MW24C 21/2 Cubic Yard Wheeled Loader
Hydraulic Lift Cylinders and Mounting Bushings
Lift cylinder bushing part number correction

Figure 145. Hydraulic lift cylinders and mounting.

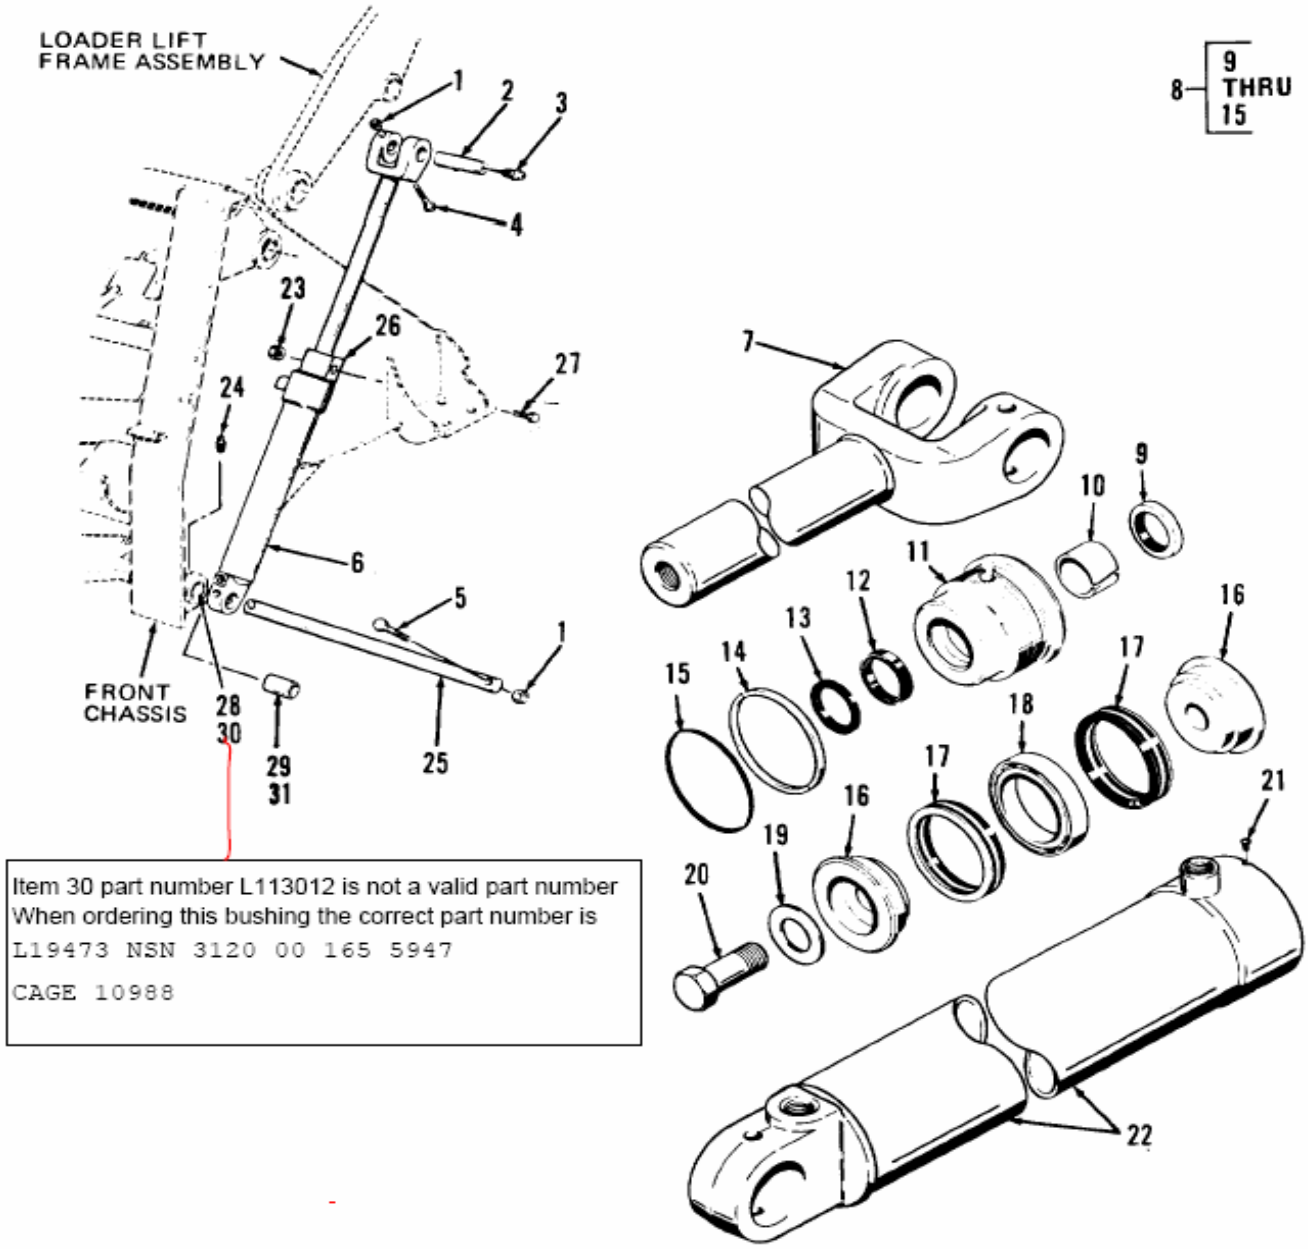
Item 30 part number L113012 is not a valid part number
When ordering this bushing the correct part number is
L19473 NSN 3120 00 165 5947
CAGE 10988
